JALIN ESTATES SUBDIVISION, RESUBDIVISION OF **LOT 2**

APPLICATION NUMBER 8 DATE May 5, 2011

APPLICANT JaLin Estates Subdivision, Resubdivision of Lot 2

DETAIL SITE PLAN

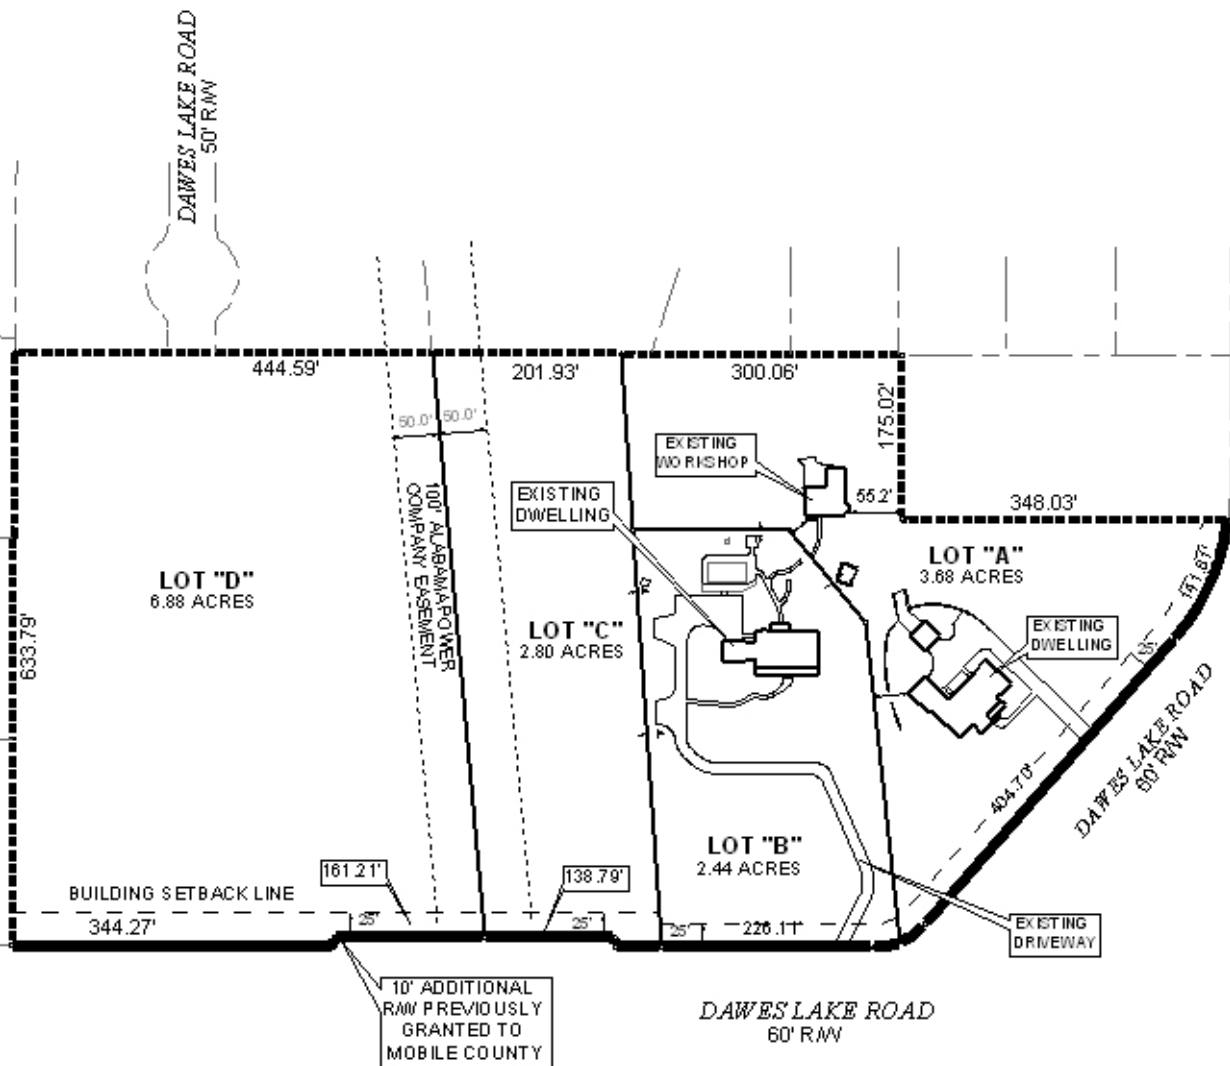
All lots would meet the minimum required lots sizes. As on the preliminary plat, the lots should be labeled with their sizes in acres and square feet on the Final Plat, if approved, or a table should be furnished providing the same information. The 25' minimum building setback line along Dawes Lake Road should also be illustrated on the Final Plat as on the preliminary plat.

The site fronts onto Dawes Lake Road, a minor street with a compliant 60' right-of-way; therefore, no dedication would be required. JaLin Estates was limited to one curb cut per lot; therefore; as a means of access management, a note should be required on the Final Plat stating that each lot is limited to one curb cut to Dawes Lake Road, with the size, location and design to be approved by County Engineering and conform to AASHTO standards.

As proposed, Lot A would require a waiver of Section V.D.1. of the Subdivision Regulations due to its irregular shape. Other irregularly-shaped lots have been approved by the Commission within the area; therefore, a waiver would be justified in this instance. Lot C would require a waiver of Section V.D.3. of the Subdivision Regulations due to its excessive depth-to-width

ratio. Again, other lots have been approved by the Commission within the area requiring such a waiver; therefore, a waiver would be justified in this instance.

Lots C and D would have a 100' Alabama Power Company easement straddling their common boundary line; therefore, a note should be required on the Final Plat stating that no structures are to be built within the Alabama Power Company easement over Lots C and D.

With a waiver of Sections V.D.1. and V.D.3., the plat meets the minimum requirements of the Subdivision Regulations and is recommended for tentative approval, subject to the following conditions:

- 1) submittal of the required seven copies of the recorded plat of JaLin Estates Subdivision prior to approval of the Final Plat;
- 2) labeling of all lots with their sizes in acres and square feet or the furnishing of a table on the final Plat providing the same information;

- 3) illustration of the 25' minimum building setback line along Dawes Lake Road;
- 4) placement of a note on the Final Plat stating that each lot is limited to one curb cut to Dawes Lake Road, with, with the size, location and design to be approved by County Engineering and conform to AASHTO standards;

- 5) placement of a note on the Final Plat stating that no structures are to be built within the Alabama Power Company easement over Lots C and D;
- 6) placement of a note on the Final Plat stating that any lots which are developed commercially and adjoin residentially developed property must provide a buffer, in compliance with Section V.A.8. of the Subdivision Regulations;
